CITY OF ALBUQUERQUE

**RE: Dennis Chavez Community Center Addition
Grading and Drainage Plan
Stamp Date 6-3-2016 (File: L14D013)**

Based upon the information provided in your submittal received 6-7-2016, the above referenced Grading and Drainage Plan is approved for Building Permit.

PROJECT NO: 5239.02
DRAWN BY: BO
CHECKED BY: GSB
GREER STAFFORD/SICF ARCHITECTURE
SHEET TITLE
GRADING PLAN

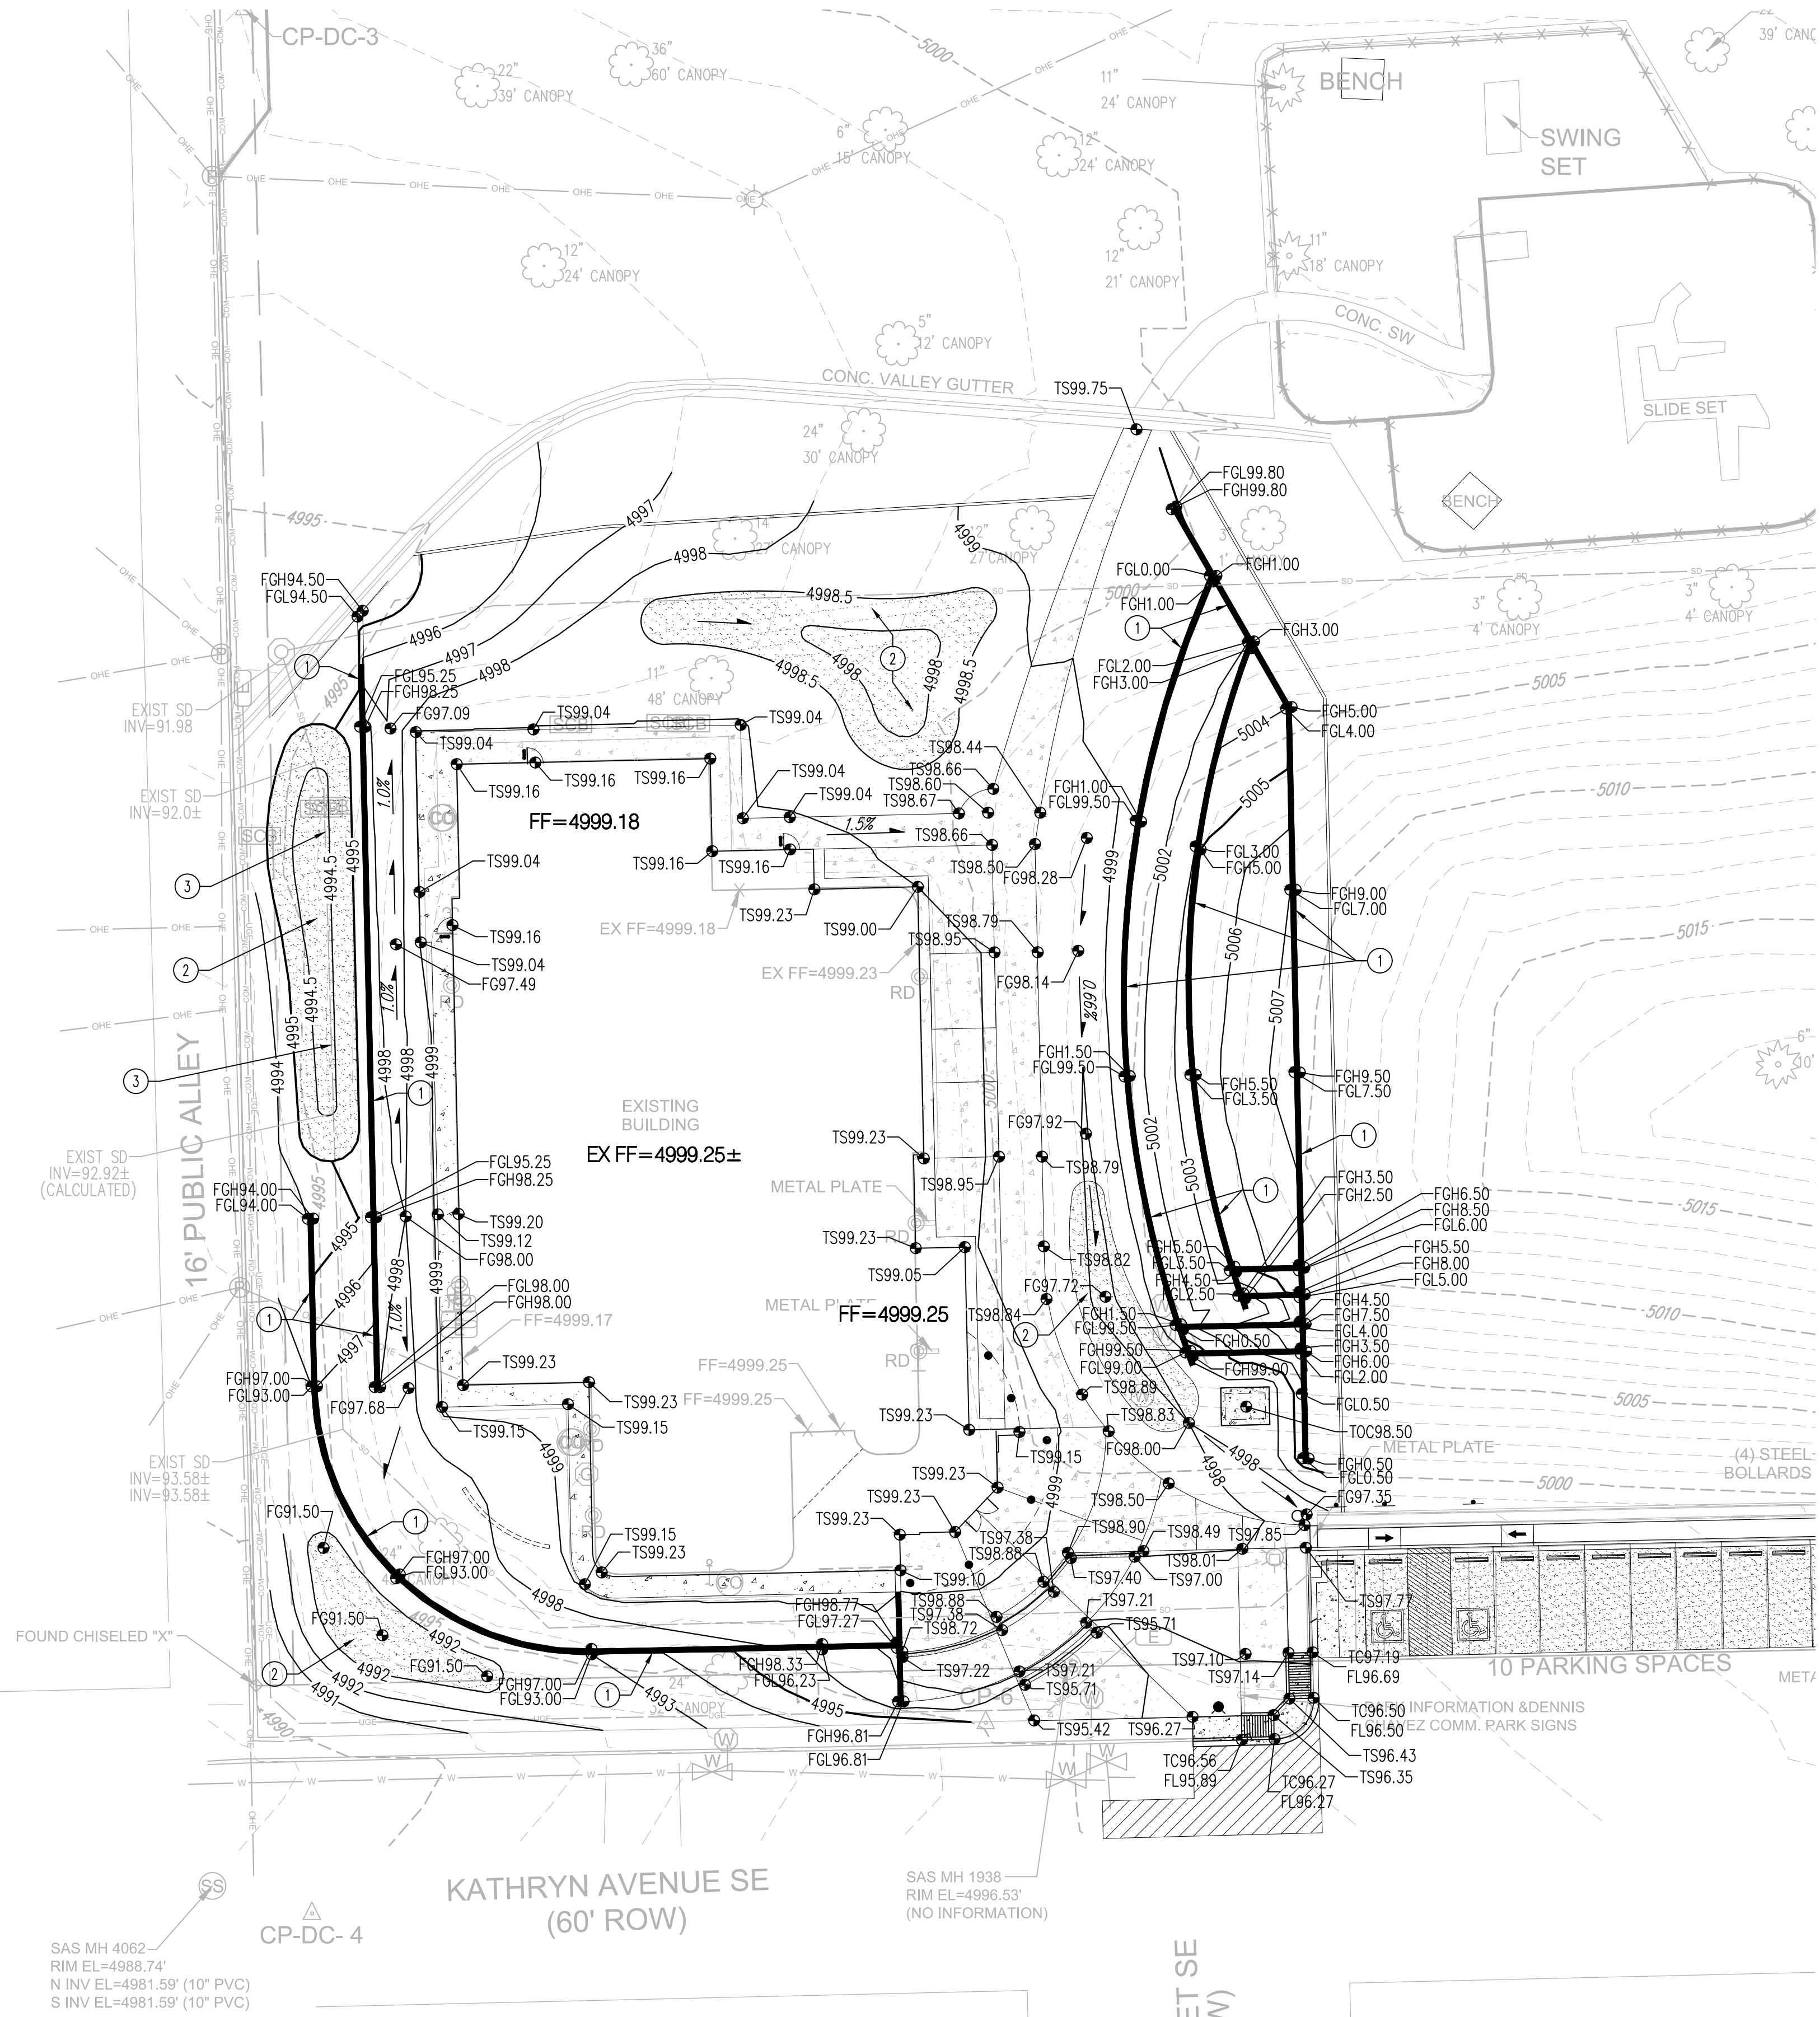
Please ensure that all new roof drains on the addition route flows under the sidewalk (it appears that there is a roof drain on the existing building that will need to be extended to the new building face not called out).
